Santa Maria Airport	Change Order No. 1
	US Customs Upgrades: Building and Site Civil	September 25, 2024

RFI #9: Shutoff for Domestic Water Line Entry

RFI #10: Weep Screed at Exterior Stucco Walls

RFI #19: Existing Ducting Clashing with New Lighting

M2.0
SHEET 13 OF 23

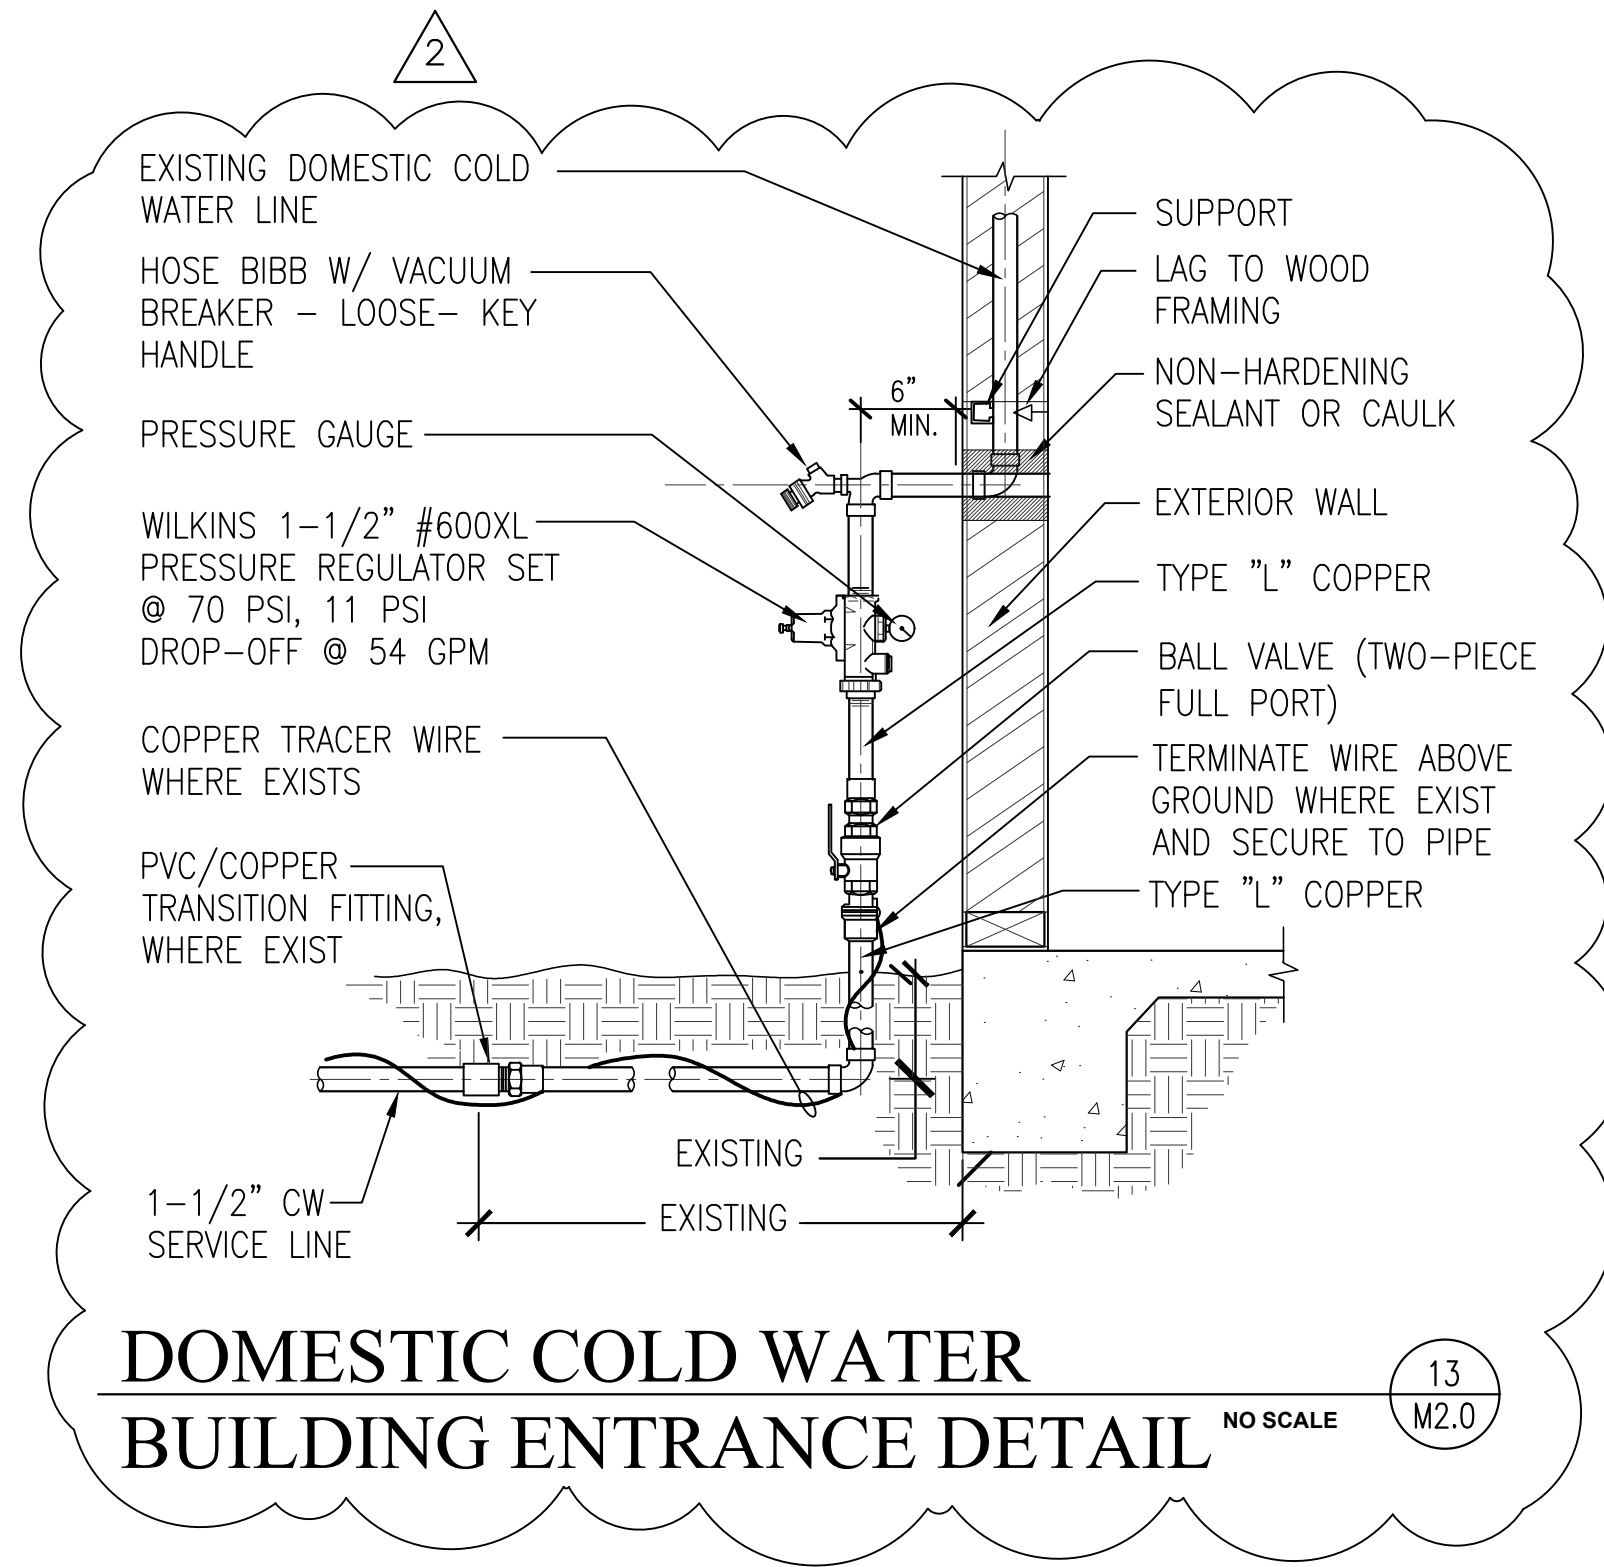
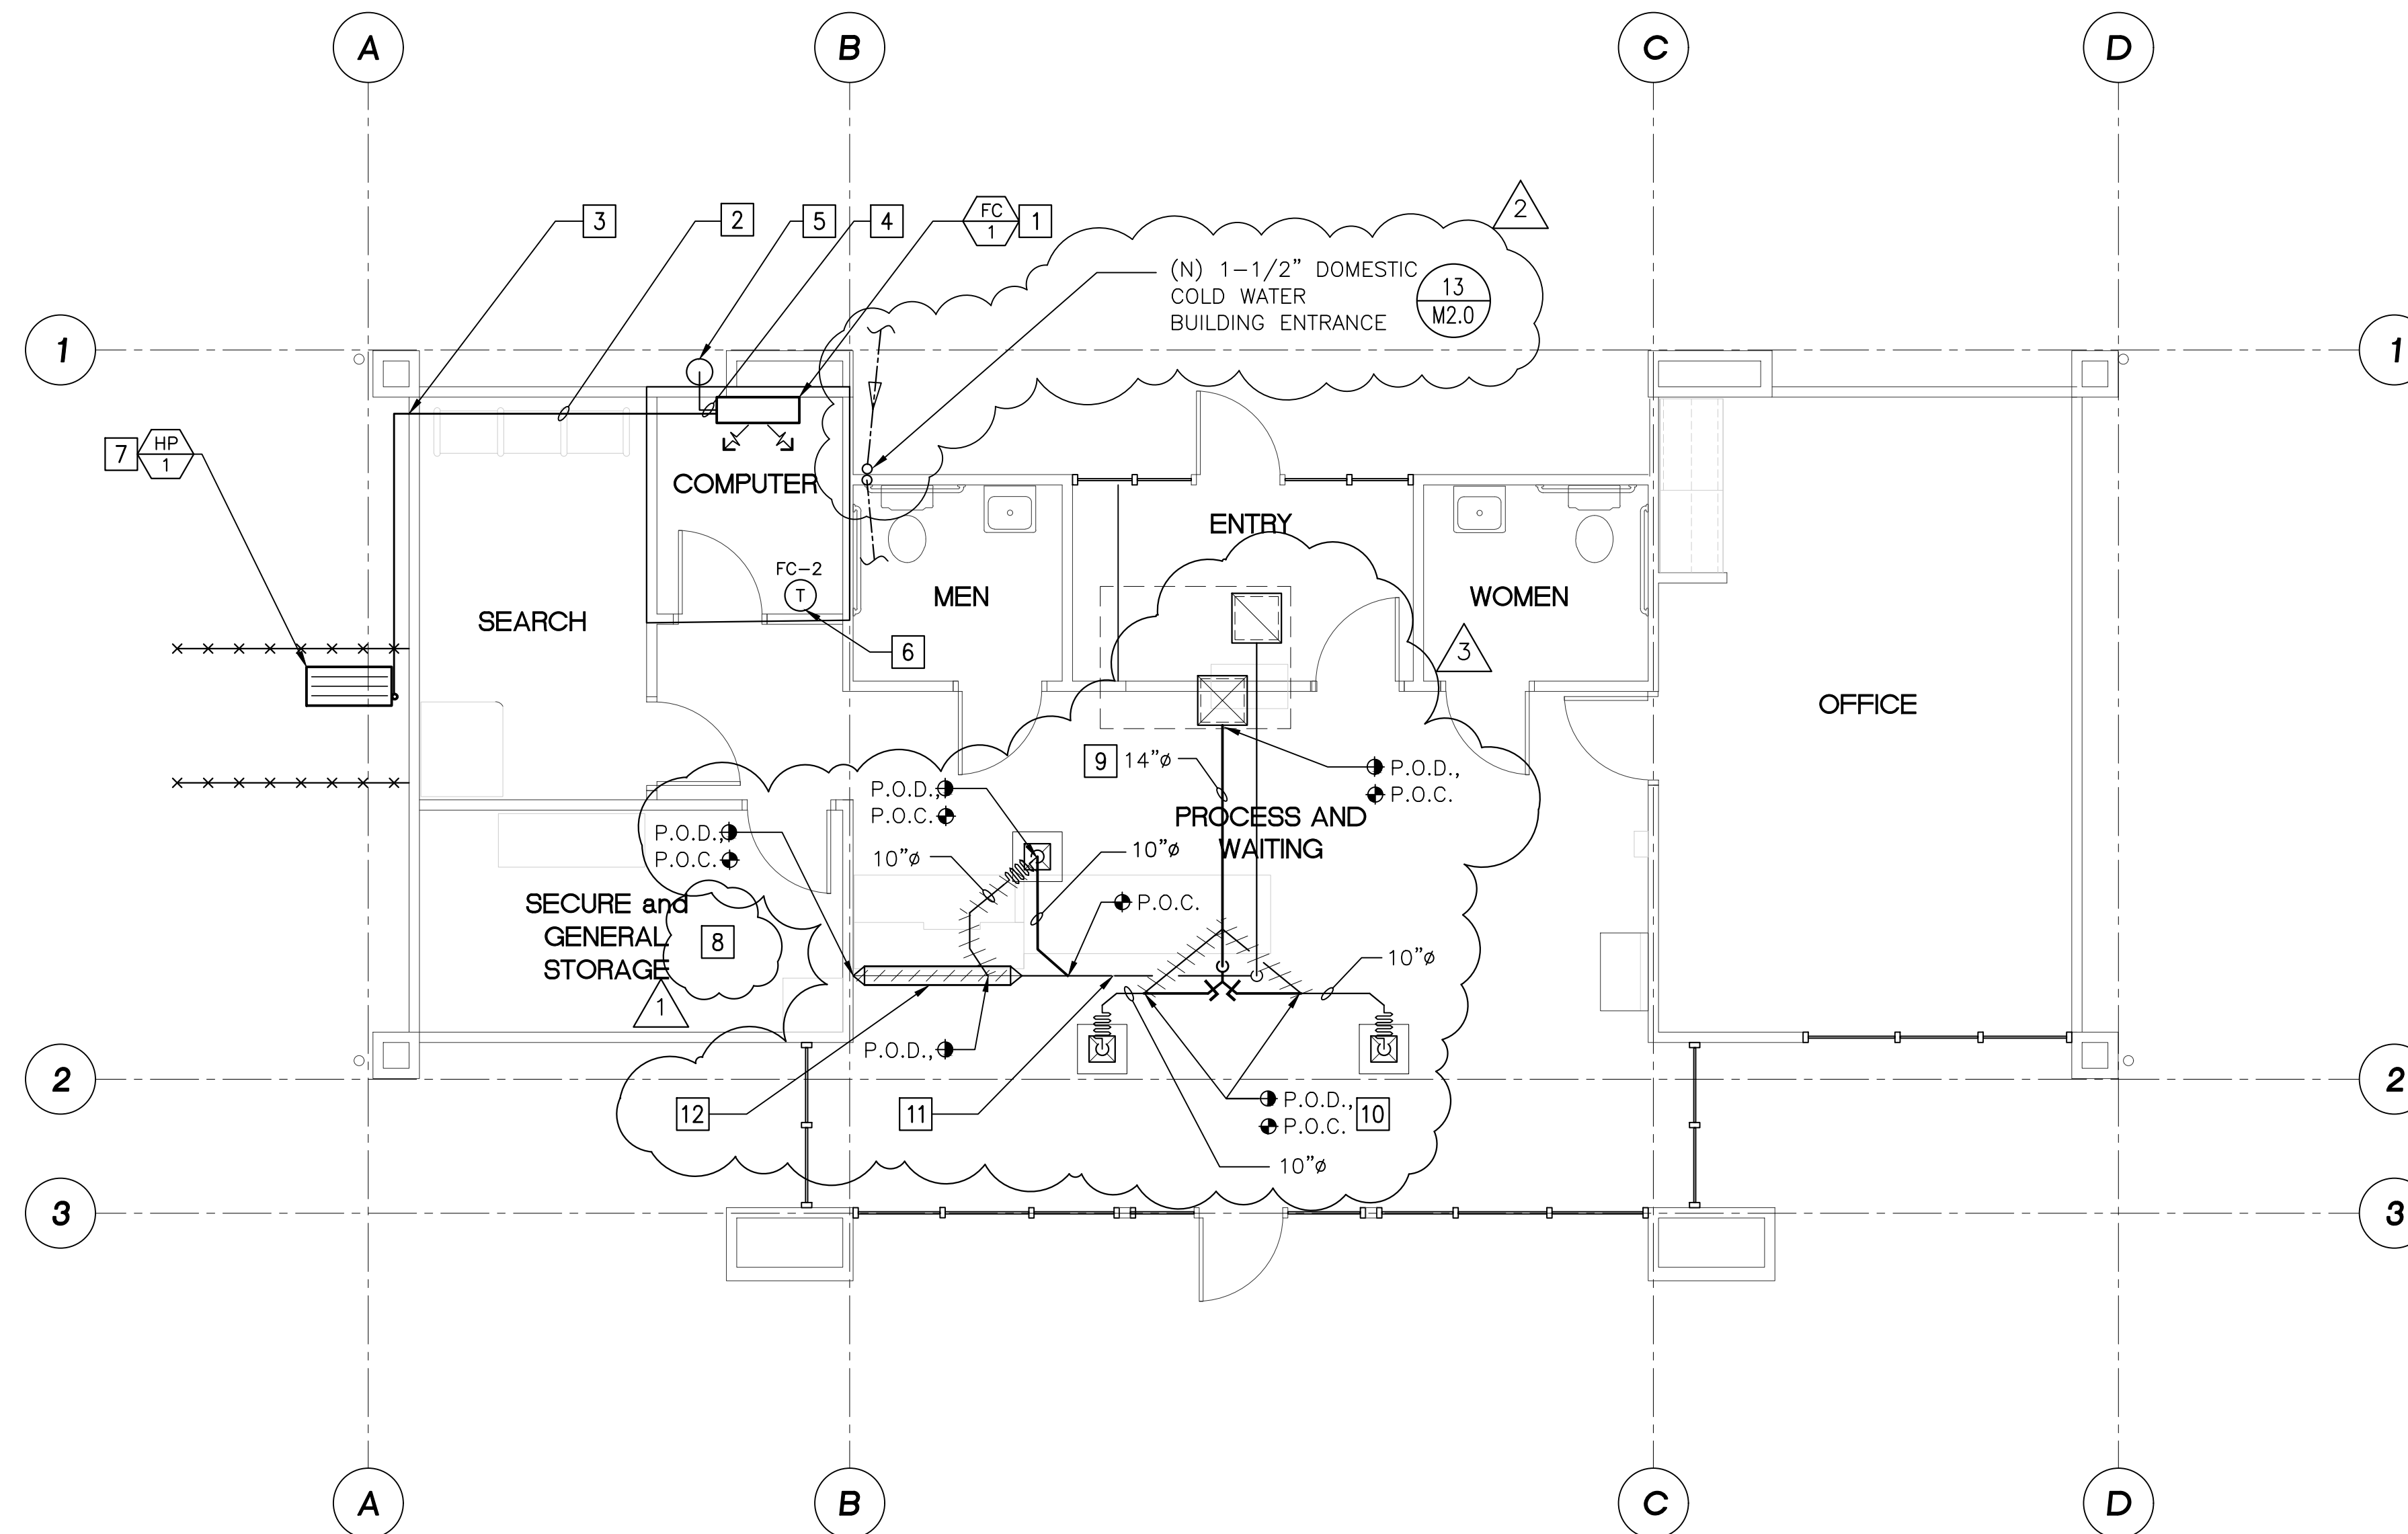
Existing return ductwork coming off of existing package unit is too low for new ceiling lights to fit into the acoustical ceiling inside the process and waiting room.
 Please confirm acceptable to change out existing 12" spiral duct return to a 6"x22" rectangular duct to allow space for the new acoustical ceiling and new lights or advise otherwise.

See attached sheet M2.0 Revision 3. Relocate supply ductwork up into joist space cavity similar to return ductwork. Replace section of return duct with rectangular duct to flatten.

- 8 REMOVE EXISTING SUPPLY AND RETURN GRILLE AND RE-INSTALL FOLLOWING INSTALLATION OF NEW CEILINGS. REMOVE EXISTING 8" SUPPLY AND RETURN DUCTS THROUGH NEW METAL MESH WALL SECURITY PANELS TO SERVE RE-INSTALLED GRILLES. NOTE: MAXIMUM OPENING SIZE THROUGH MESH IS 9-1/2" x 9-1/2".
- 9 RAISE EXISTING SUPPLY DUCT UP TO BETWEEN ROOF JOIST - SIMILAR TO RETURN DUCT.
- 10 RELOCATE EXISTING BRANCH DUCTS.
- 11 RAISE EXISTING RETURN DUCT UP TO BOTTOM OF ROOF JOISTS.
- 12 REPLACE EXISTING 12"Ø DUCT WITH 16"x8" DUCT, THIS AREA.

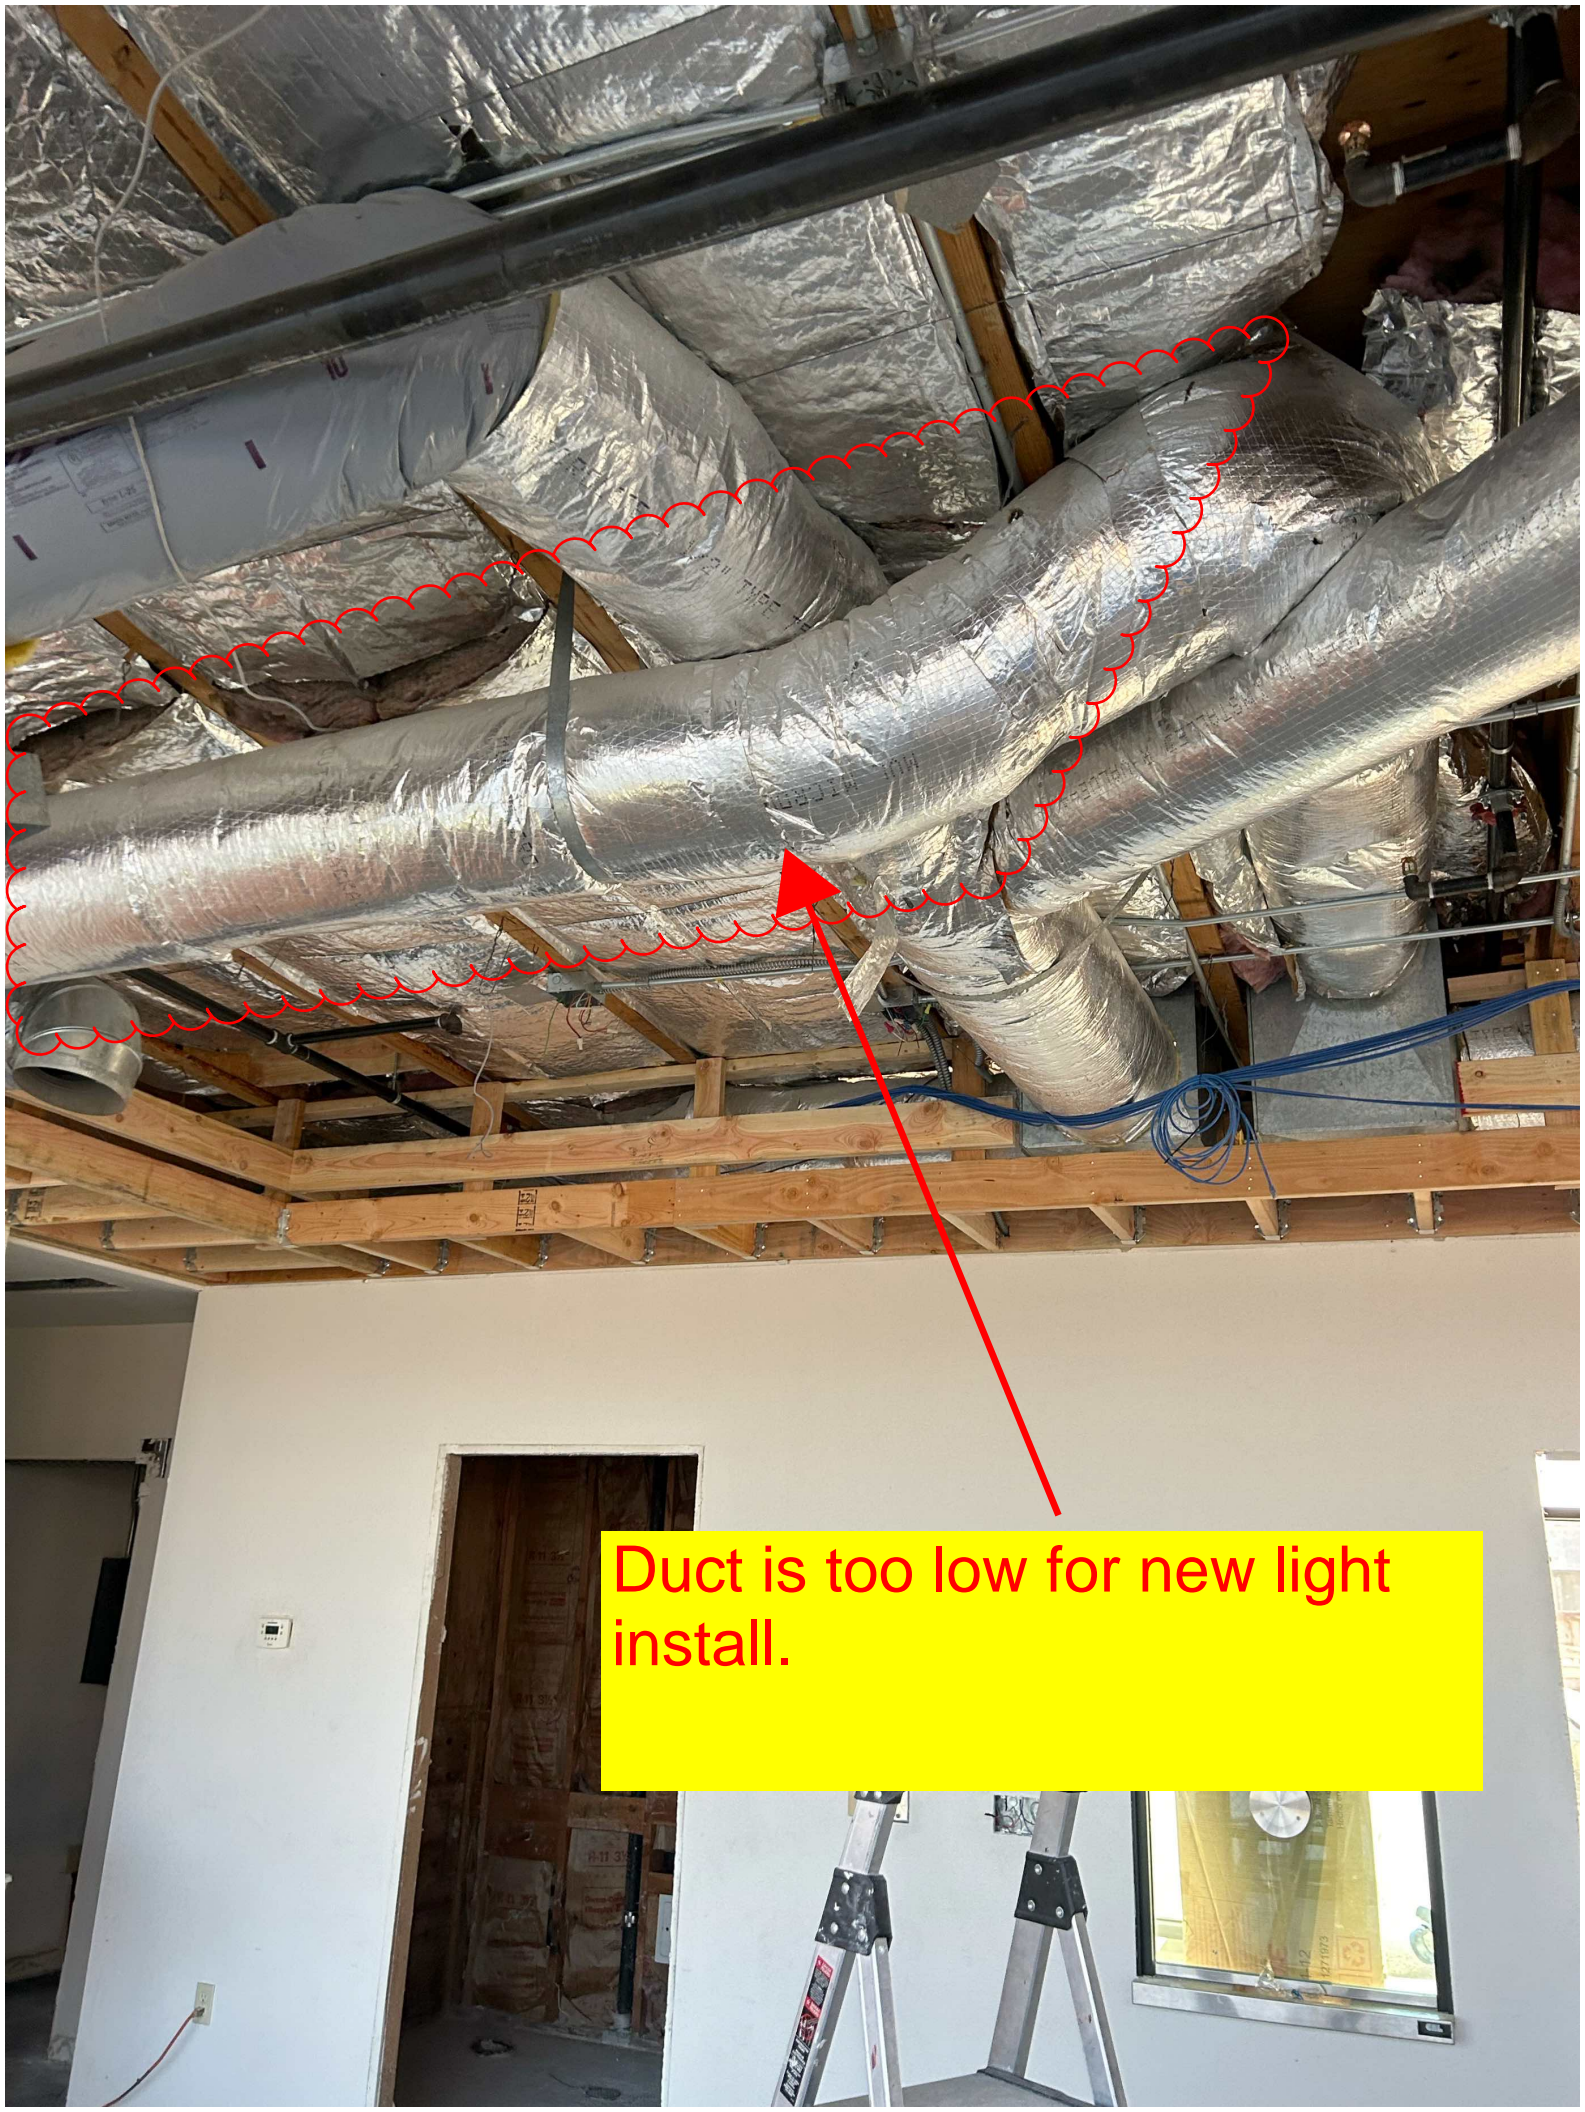
Duct is too low for new light install.

Duct Is too low for new light install.
